PROJECT COMMENTS

PROJECT NUMBER: SP2025-018

PROJECT NAME: Site Plan for 3070 N Goliad Street

SUBJECT: SP2025-018; Site Plan for 3066 & 3068 N. Goliad Street

A00.50

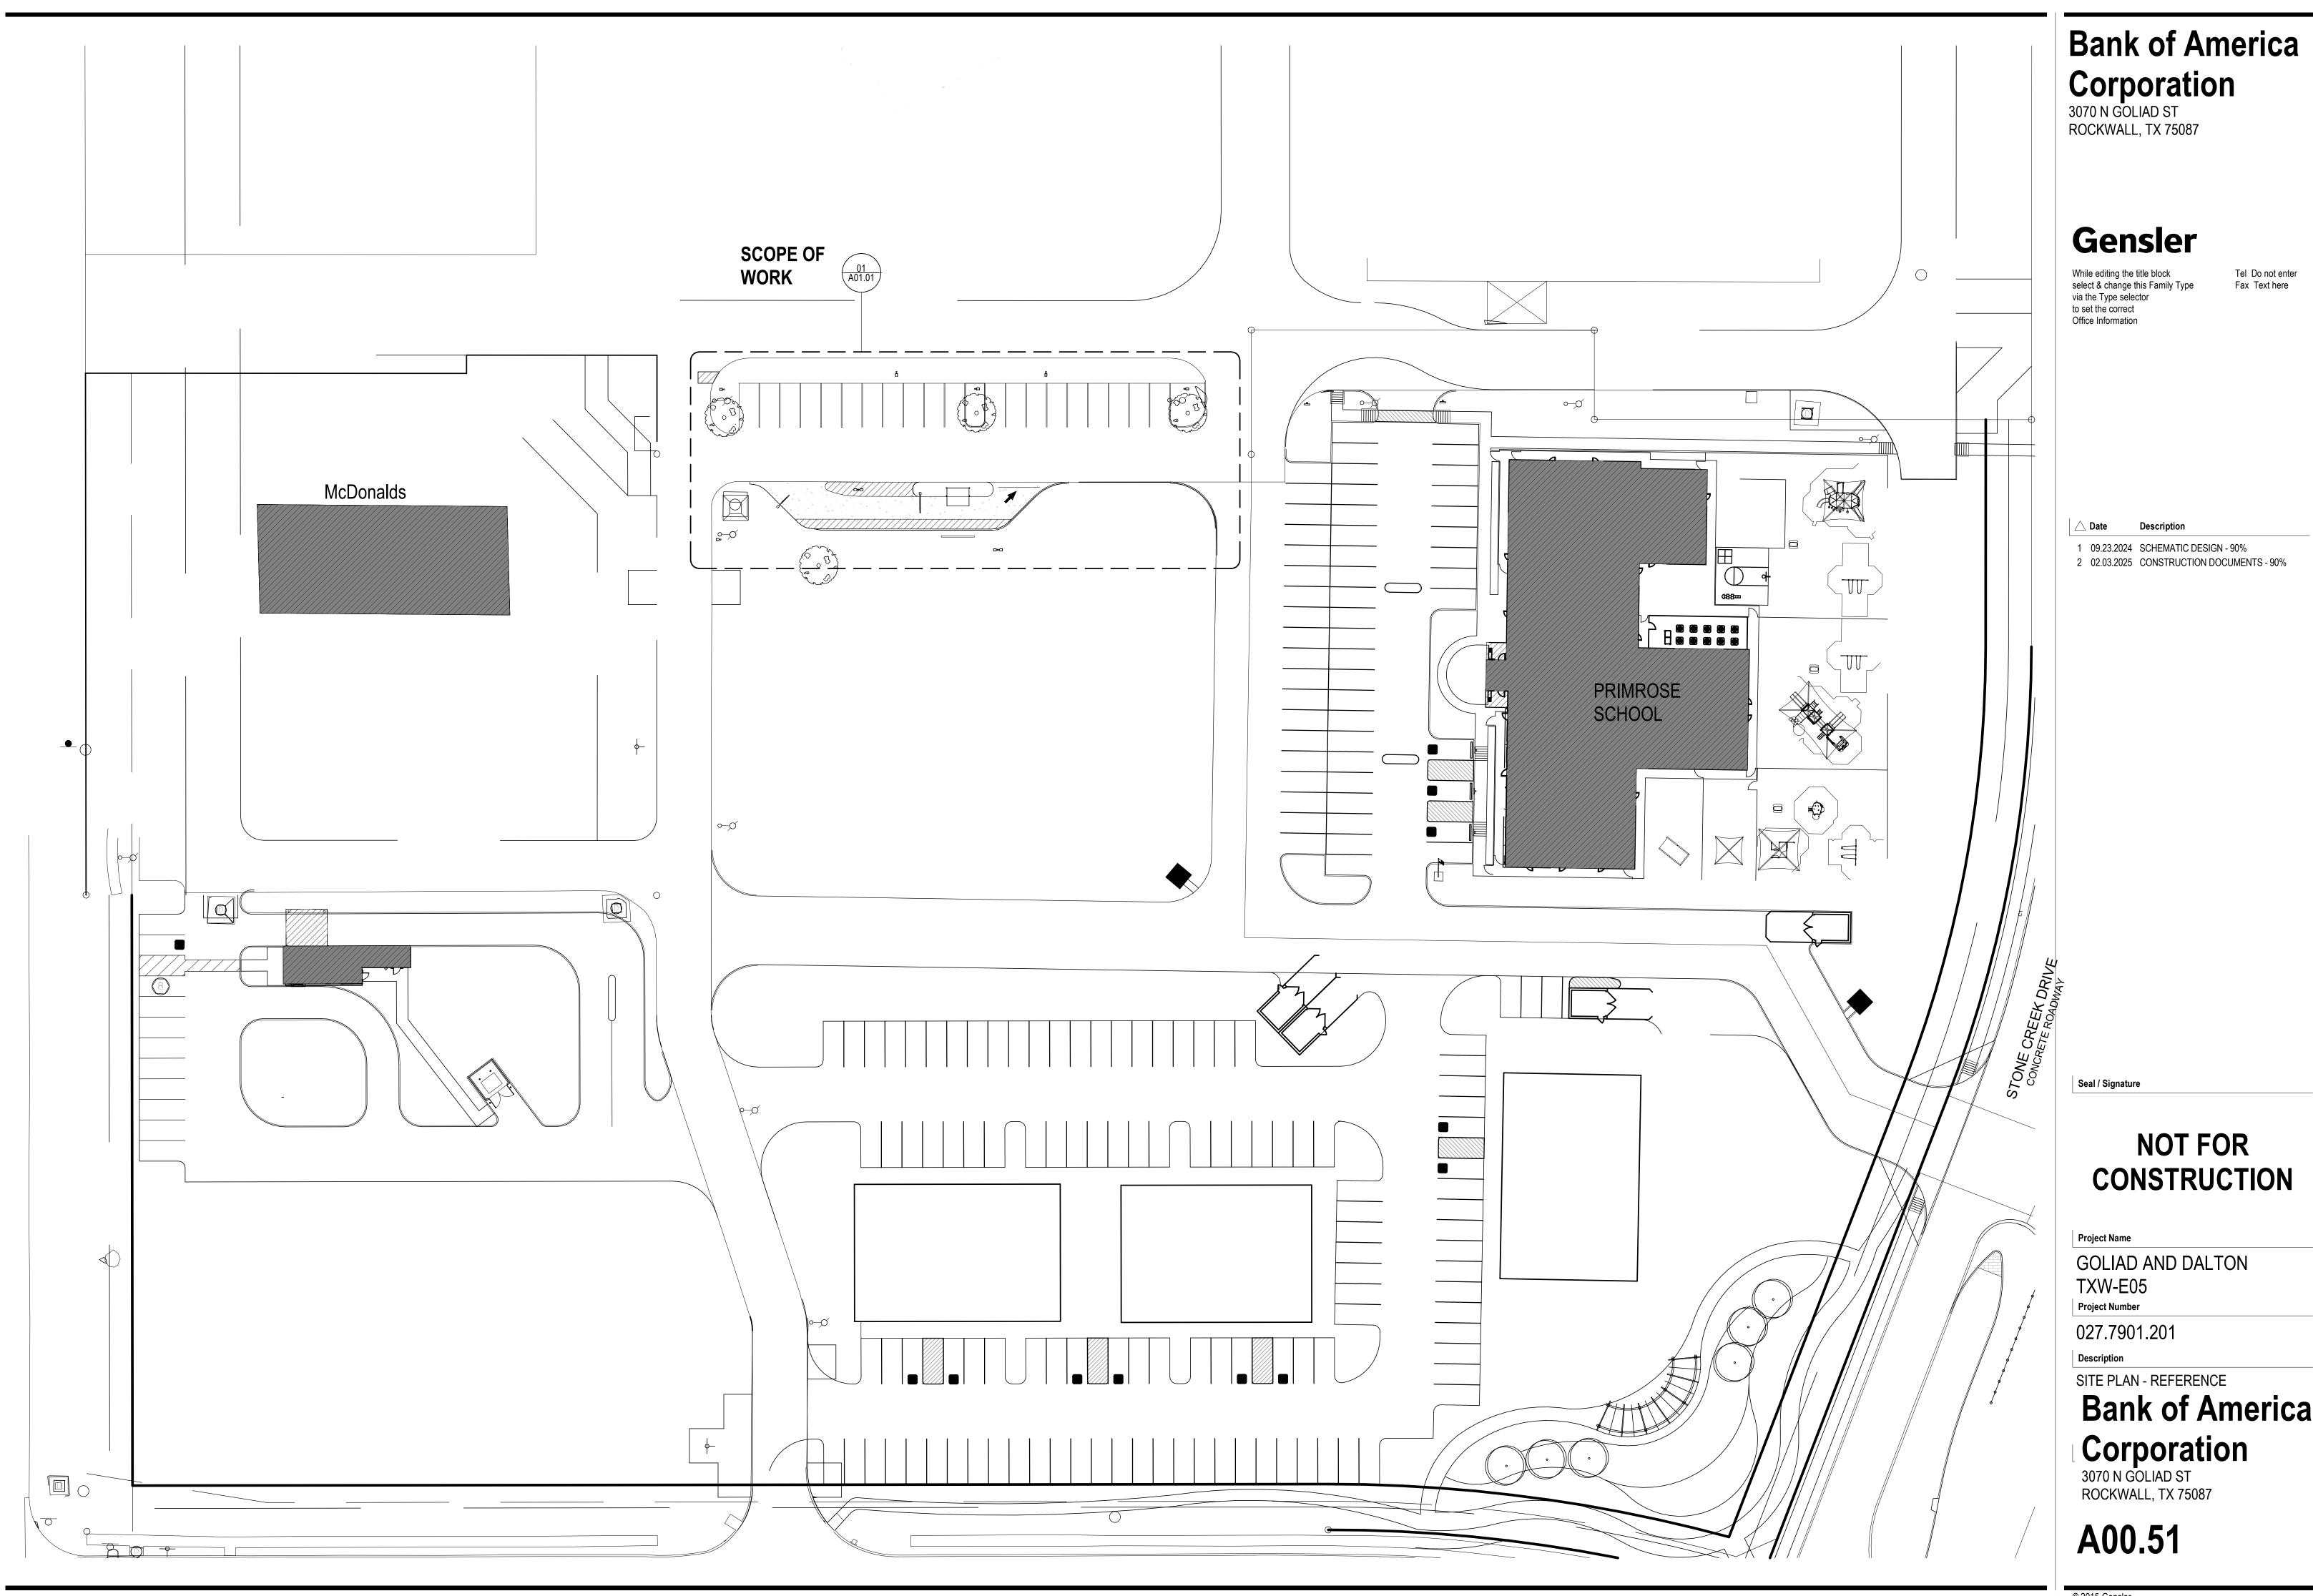
M.6 Site Plan.

- (1) According to the Planned Development District 70 (PD-70) Ordinance (Ordinance No. 19-41), land uses shall not be separated by screening walls of physical barriers. In this case, there is a proposed metal screening wall. This will be an exception to the PD-70 requirements. (PD-70; Ordinance No. 19-41)

- (2) According to the Planned Development District 70 (PD-70) Ordinance (Ordinance No. 19-41), non-residential development shall be compatible with the surrounding residential and integrated with the adjacent uses through the use of landscape buffers and building design. In this case, there is no proposed landscaping or any building materials that will tie in the proposed structure with the surrounding development. This will be an exception to the PD-70 requirements. (PD-70; Ordinance No. 19-41)

- (3) Please indicate any ground mounted equipment. On the landscape plan provide the necessary five (5) gallon evergreen shrubs for screening. (Subsection 01.05. C, of Article 05, UDC)

- (4) The proposed Incidental Display does not meet the following Incidental Display requirements. Each shall constitute an exception to the Unified Development Code (UDC). (Subsection 02.03, of Article 04, UDC)

- (c) Any outside sales and display not located on a covered sidewalk must be screened from view of adjacent roadways, public areas and adjacent properties. In this case, the Incidental Display from adjacent roadways and adjacent properties.

- (d) Screening must be a minimum of eight feet high or one (1) foot taller than the materials being displayed, whichever is greater. In this case, the screening does not appear to be one (1) foot taller.

- (e) Screening must include a minimum of 20.00% solid screening matching the material of the primary building. The remainder may be solid evergreen planting, or wrought iron or decorative metal fence. In this case, the screening is a solid metal wall.

- (f) Any outside sales and display not located on a covered sidewalk must be located immediately adjacent to or connected to the primary structure. In this case, the Incidental Display is located immediately adjacent to or connected to a building.

05/22/2025: 1. You will need to ask for a variance for not providing a bypass lane.
